0012933

OFFICE OF SACRAMENTO
COUNTY BUILDING DEPARTMENT
SACRAMENTO, CALIFORNIA

93 Celoms

Frame

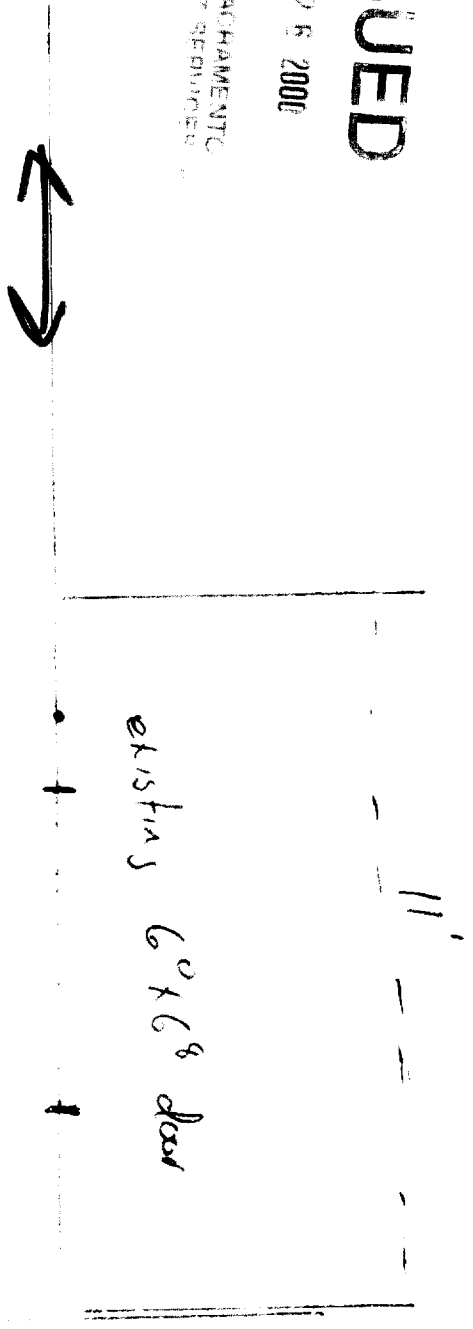
- 1.) Move existing light fixture
- 2.) New step below door
- 3) New Header to be 2x12 or 4x12.

* Verify adequate brace
 wall panels along these lines
